RE: Zoning Challenge
1059 Third Avenue
Block 1417, Lot 47
Job No: 121187599

Summary of findings

Axonometric view of 1059 Third Avenue color coded using traditional land use colors

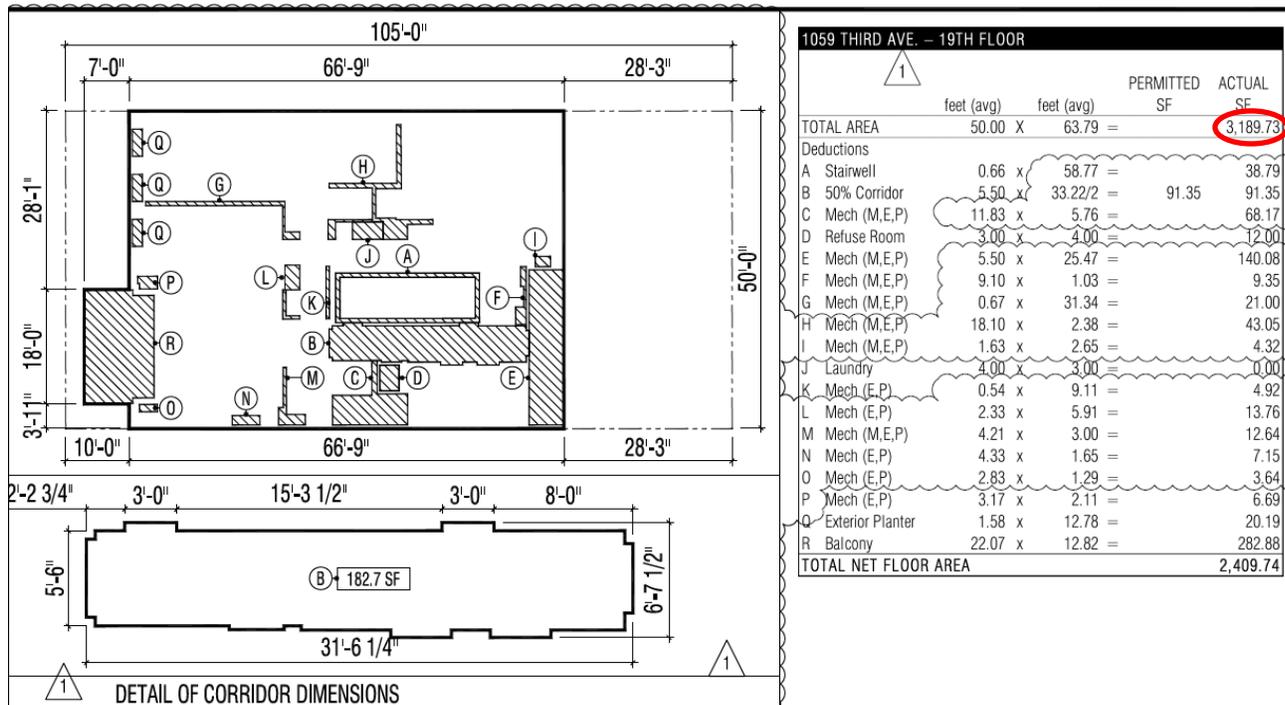
My office modeled a massing of the building as proposed, shown below. Yellow areas are residential floor area, gray areas are mechanical spaces and red areas are commercial.

Reproduction of the 19th floor from Z-002-03, with claimed gross floor area number circled

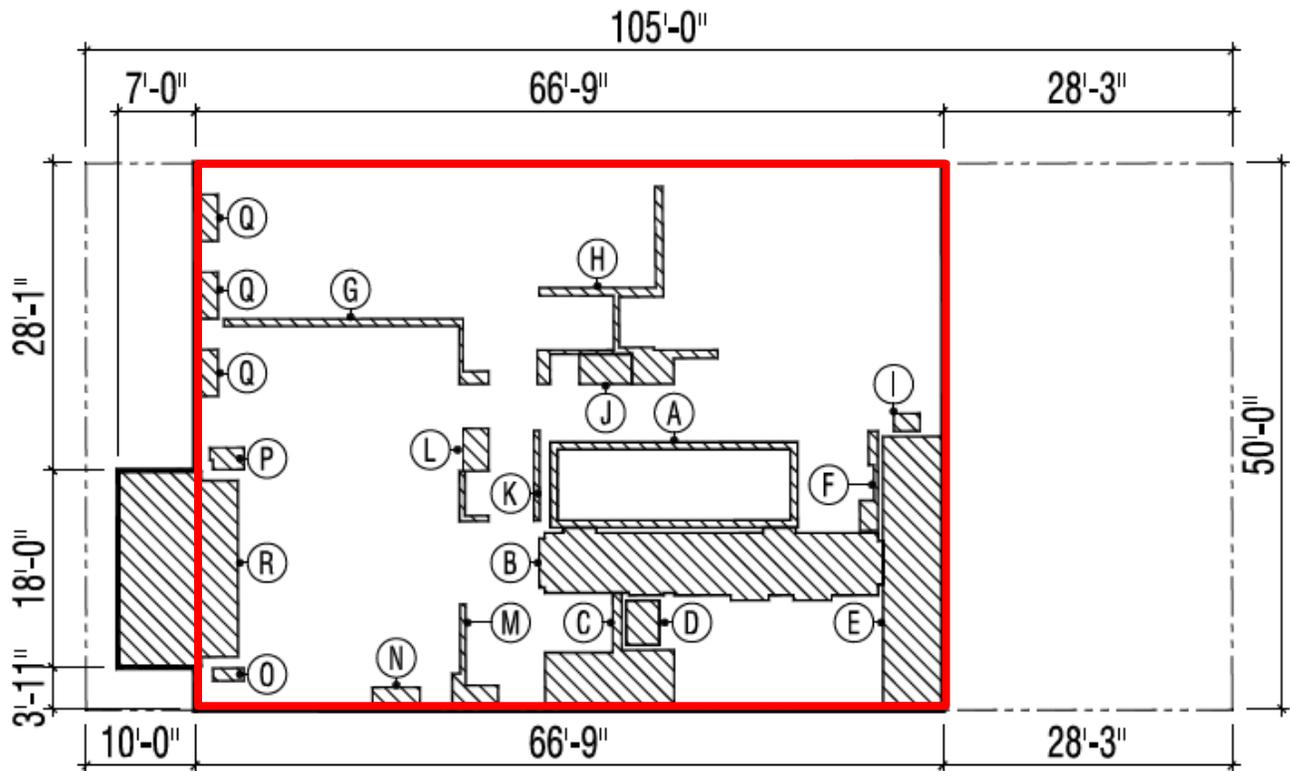
Below is a reproduction of the 19th floor from the Z-series plans. On the left, we see the 19th floor in plan and the areas deducted. On the right, we see a table showing the size of those areas deducted. Those deductions are subtracted from a number at the top of the table that I have circled in red.

In theory, the number circled in red is the gross floor area for this floor. The table shows that it is calculated by the numbers shown in this table: 50' by 63.79', which equals 3,189.73 SF.

But where does 63.79' come from? The depth dimension on the plan reads 66' 9", not 63.79'. If we just measure the gross floor area as described by the red line, leaving out part of the balcony, the gross floor area is 3,337.50 SF. This area is shown below on the same plan for floor 19.

Detail of the 19th floor plan from Z-002-03 with the area inscribed by the outer walls in red

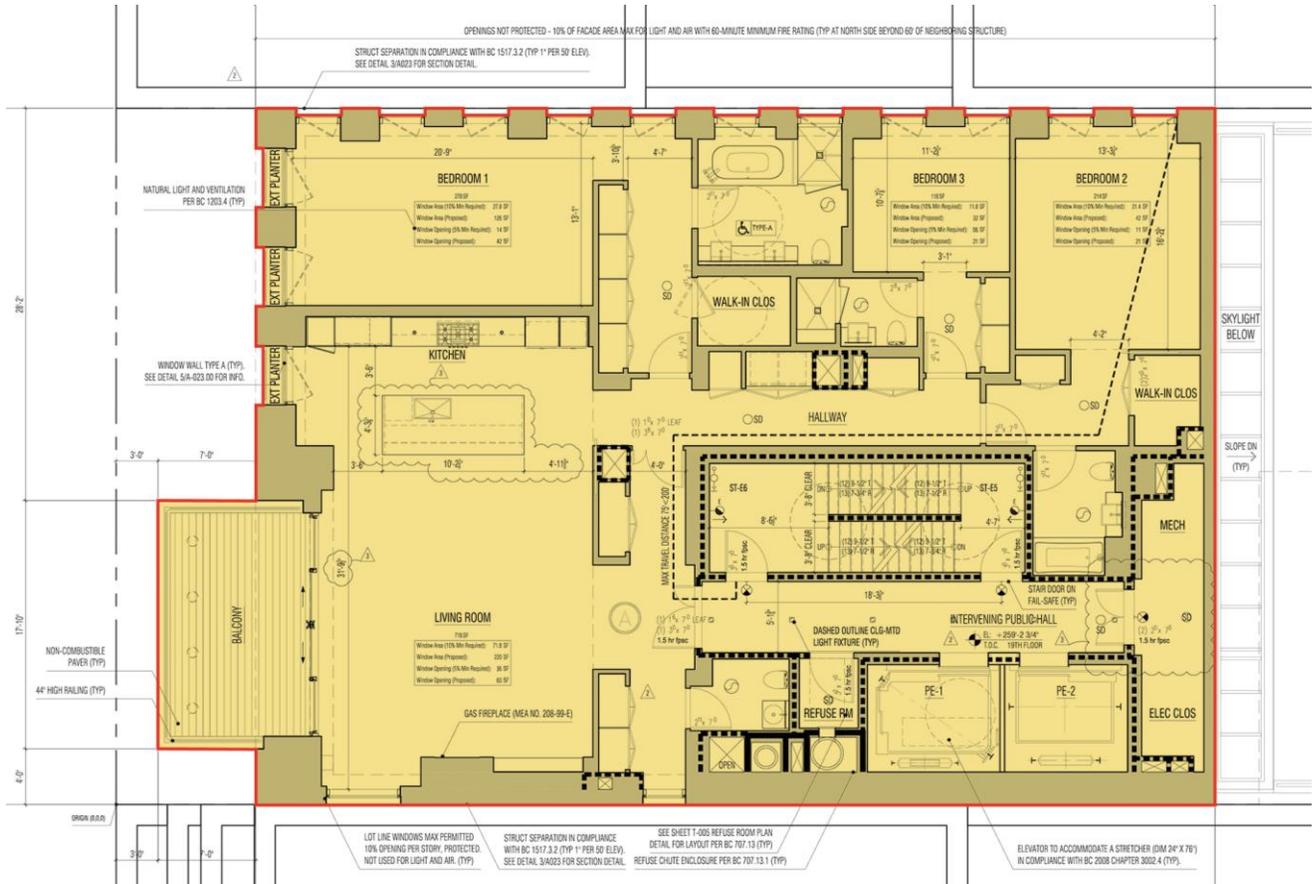
The 3,337.50 SF also cannot be the correct gross floor area, since just following those dimensions leaves out most of item R, the balcony, which the applicant deducts from the gross floor area. The plan shows that part of the balcony is 7' by 18' or 126 SF, which makes the total gross floor area shown in the drawing equal to 3,463.50 SF.

Consequently, the applicant is showing two different gross floor area numbers in this single drawing of the 19th floor. The first, 3,189.73 SF, is shown in the table, and is the starting point from which all floor area deductions are taken. The second, 3,463.50 SF is shown in the plan when simple geometry is applied to the drawing using the dimensions provided. The difference, 273.77 SF, is a substantial amount of floor area. By leaving it out of the gross floor area, it is never carried to the zoning floor area.

Detail of the 19th floor plan from A-022-03 showing an area used for gross floor area inscribed by red line

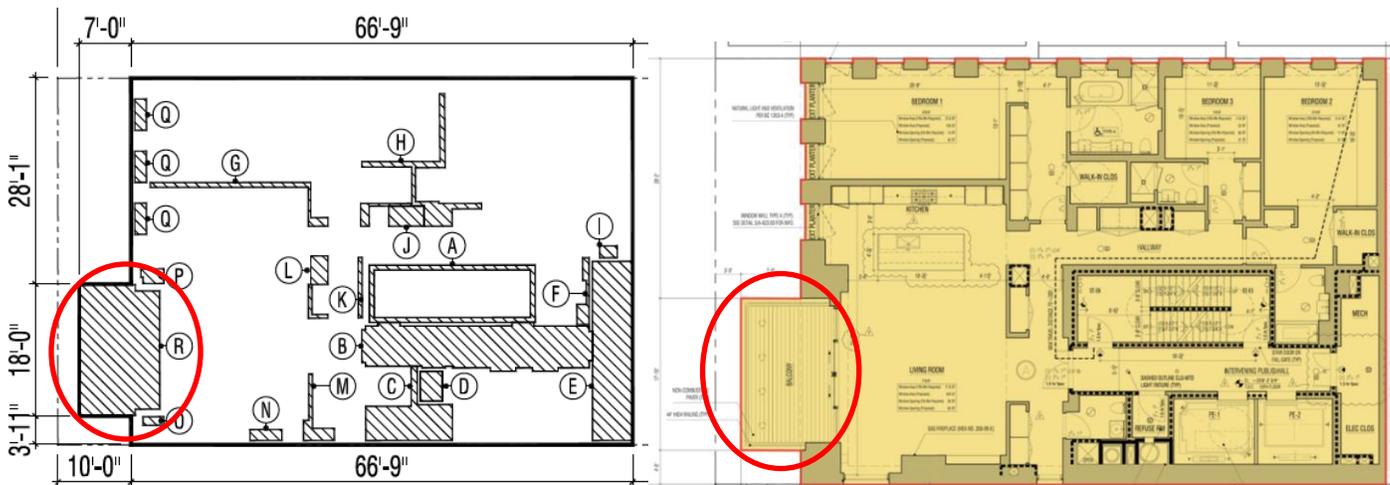
The drawing dimensions show that the floor plate measured to the exterior wall is 50' by 68' 10" or 3,441.5 SF. This is more than a full two feet deeper than the dimension shown on the Z-series. But that is measuring the exterior building wall at its largest, ignoring exterior wall articulation. When we measure the area inscribed by the red line in CAD, we get 3,542.95 SF, which is 353.22 SF larger than what is shown on the Z-series.
